SERVICE BULLETIN

N° **139-444**

REV. : C - June 28, 2018

ATA 78 - EXHAUST DUCTS AND REAR FIREWALL RETROMOD

Figure 38

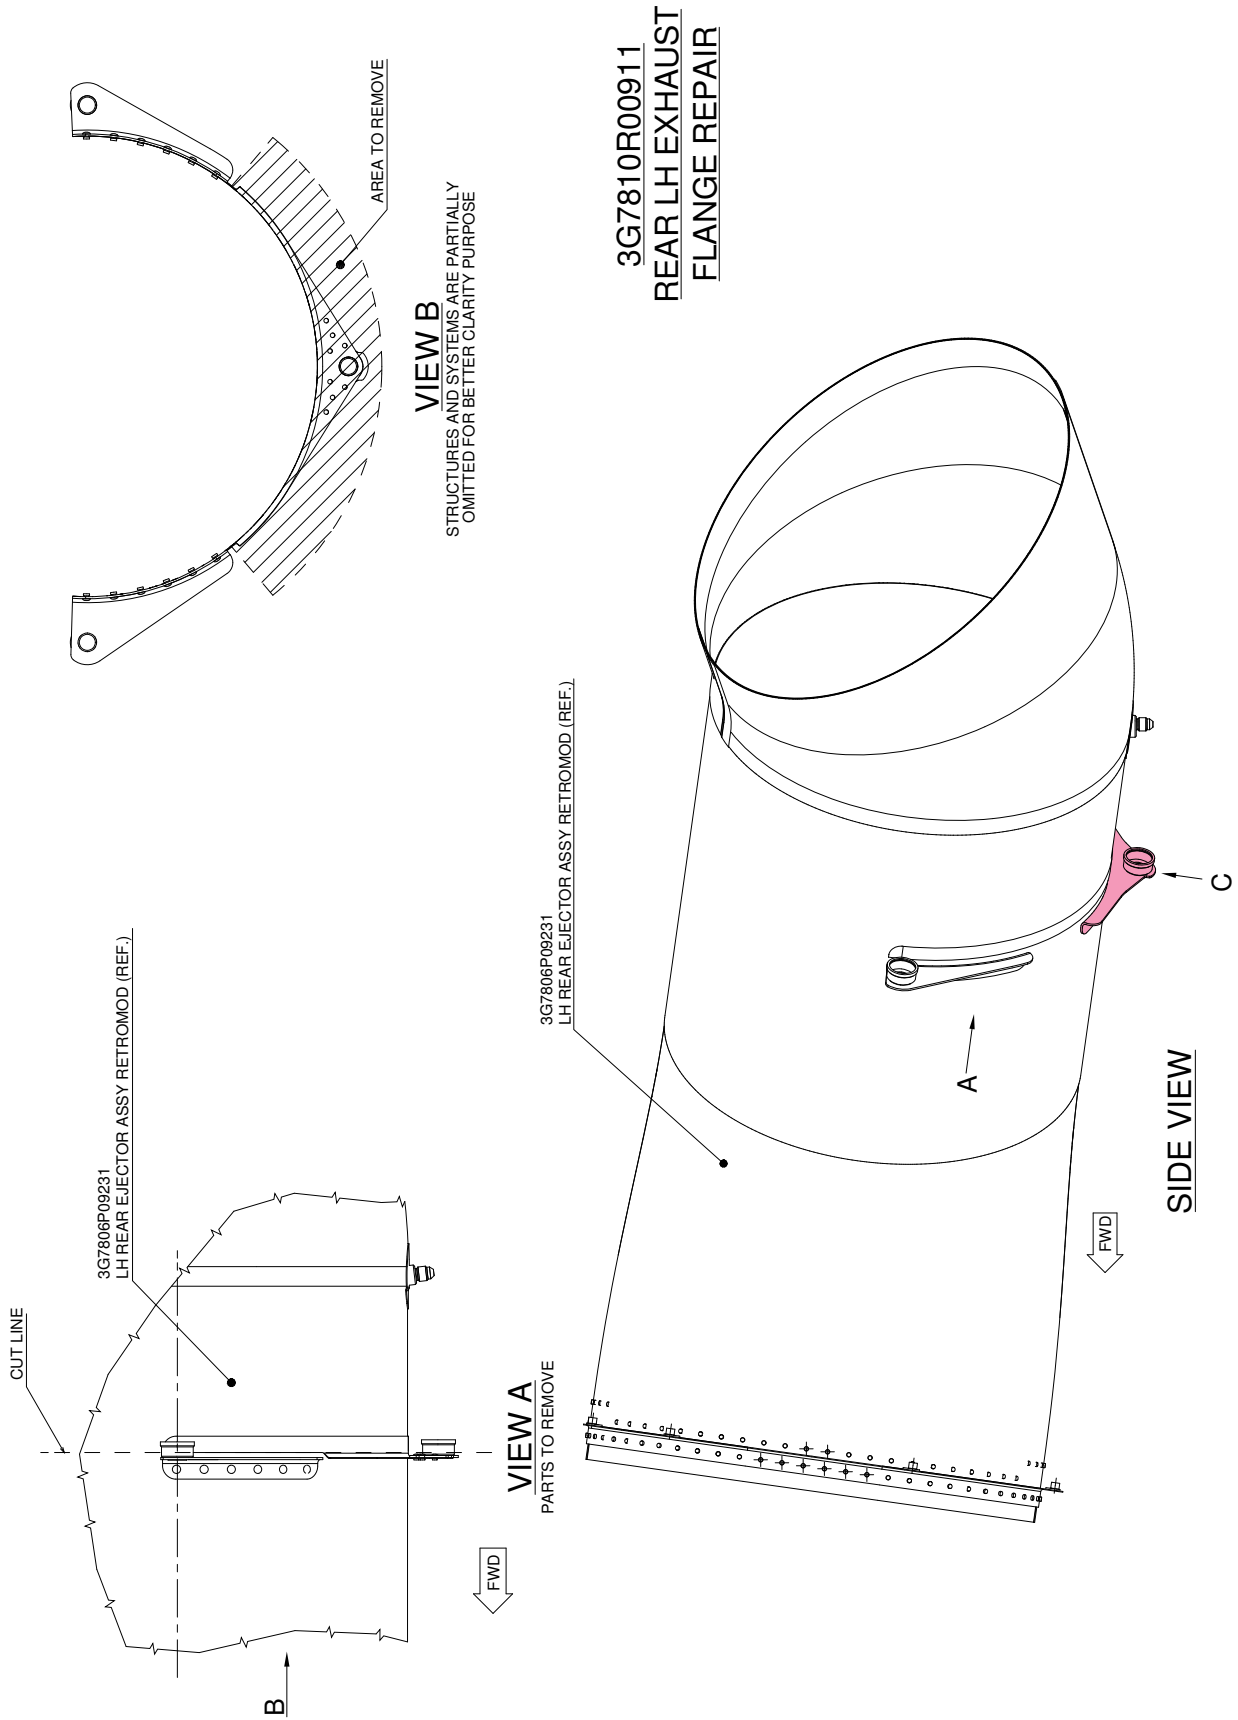
- 3.11 With reference to Figure 9 view L and section P-P, install central cup assy P/N 3G7810A14031 and doubler P/N 3G7810A18451 by means of n°8 rivets P/N NAS1200-3-5.
- 3.12 With reference to Figures 38 and 39, perform the rear left exhaust flange repair P/N 3G7810R00911 as described in the following procedure:
- 3.12.1 With reference to Figure 38, remove the indicated area.
- 3.12.2 With reference to Figure 39, install the central flange LH assy P/N 3G7810A18731 by means of n°7 rivets P/N MS20615-4M4R.

Figure 40

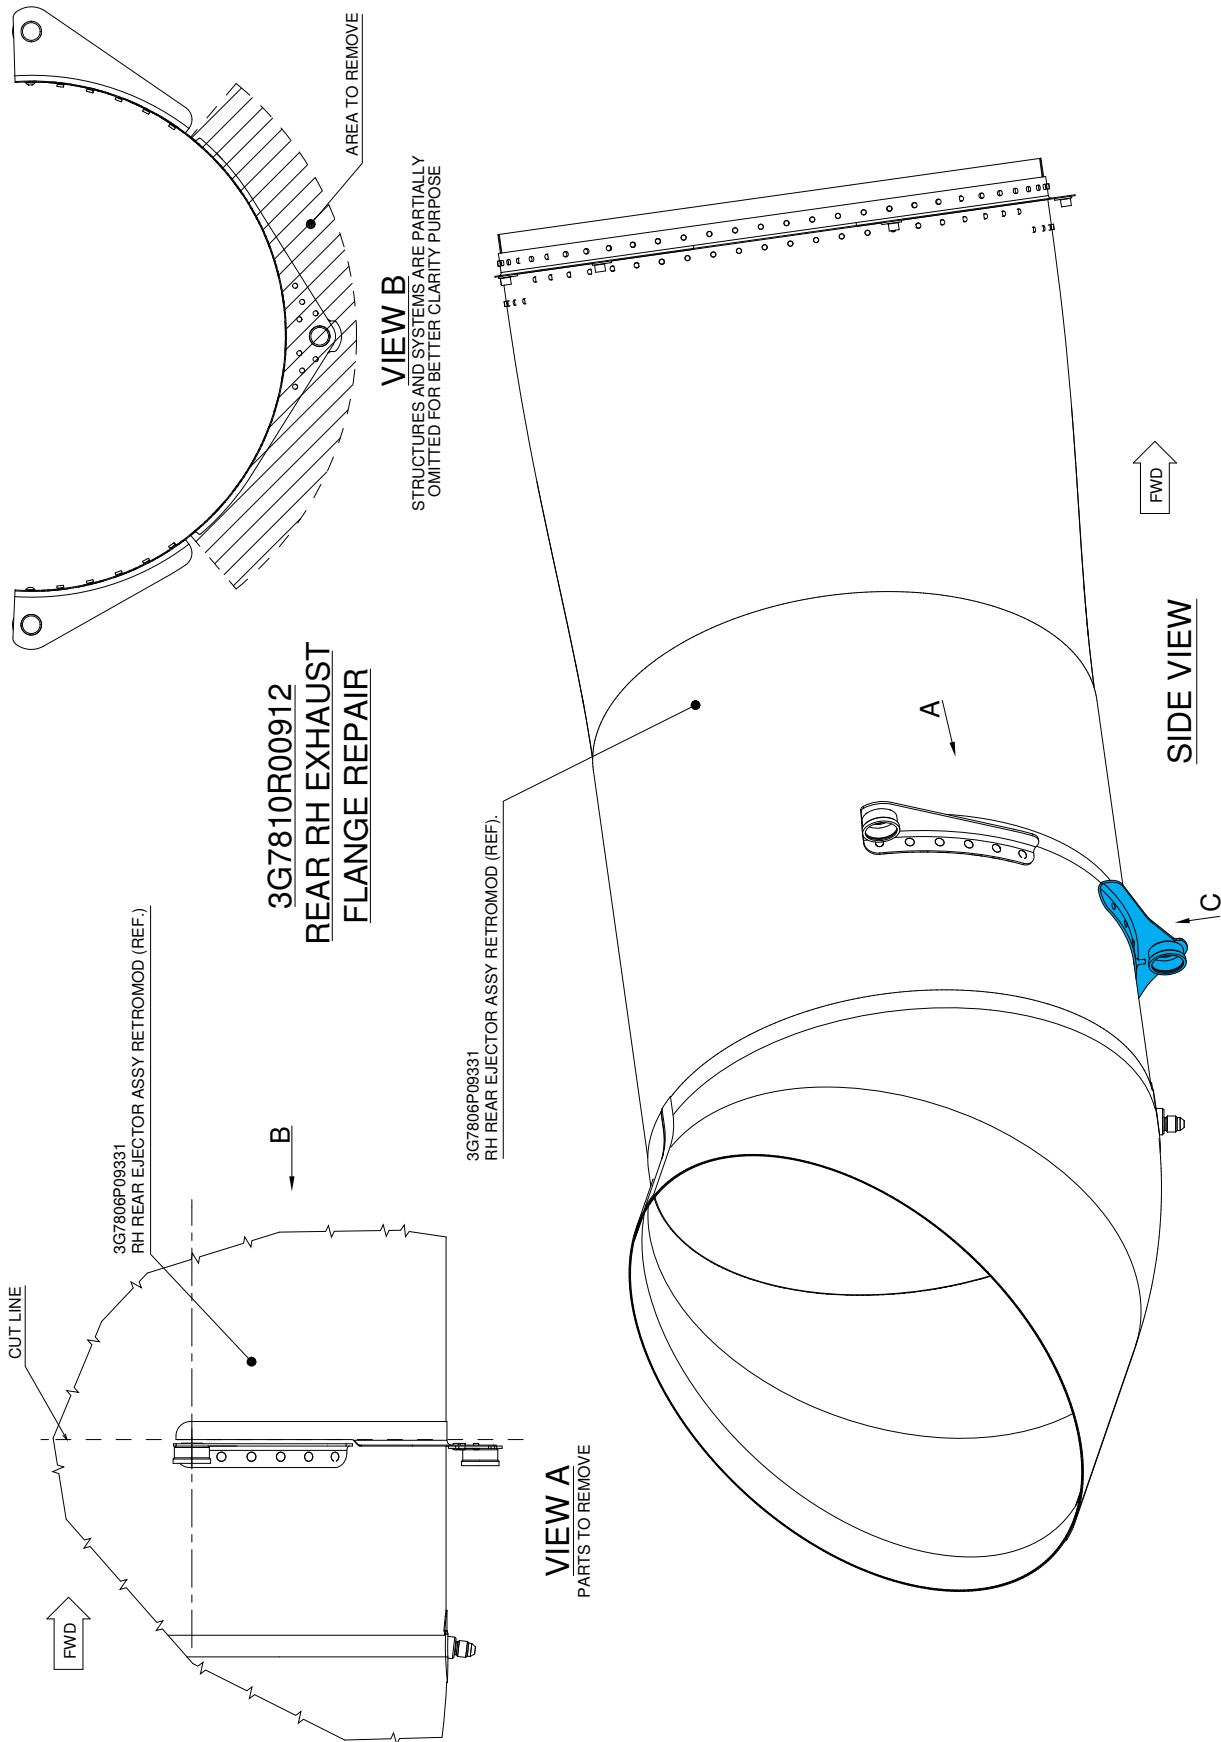
- 3.11 With reference to Figure 13 view L and section P-P, install central cup assy P/N3G7810A14031 and doubler P/N 3G7810A18451 by means of n°8 rivet P/N NAS1200-3-5.
- 3.12 With reference to Figures 40 and 41, perform the rear right exhaust flange repair P/N 3G7810R00912 as described in the following procedure:
- 3.12.1 With reference to Figure 40, remove the indicated area.
- 3.12.2 With reference to Figure 41, install the central flange RH assy P/N 3G7810A18831 by means of n°7 rivets P/N MS20615-3M4.
